Product Change Notification

110907 - 01

Change Notification #: 110907 - 01
Change Title: Intel® Desktop Board DP67BA, Boxed and Bulk
PCN 110907-01, Product Material
Replace PWM CONTROLLER
Reason for Revision: Add CPU Socket Cover change
Date of Publication: August 10, 2011

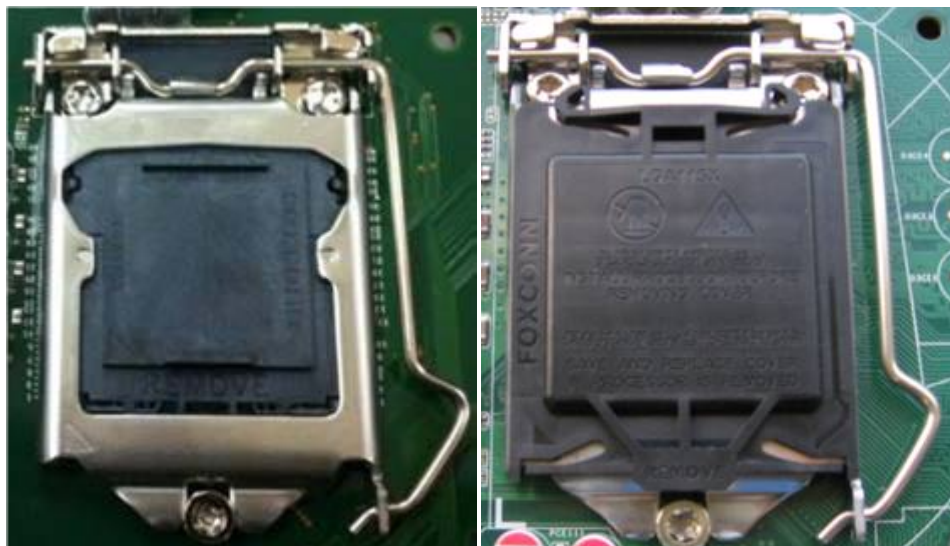
1. The Pulse Width Modulation controller CHIL 8104 upgraded from version E4 to E5 to enhance performance.
2. The CPU socket cover will be changed to the ILM version.

Current socket with PNP cover

New socket with ILM cover
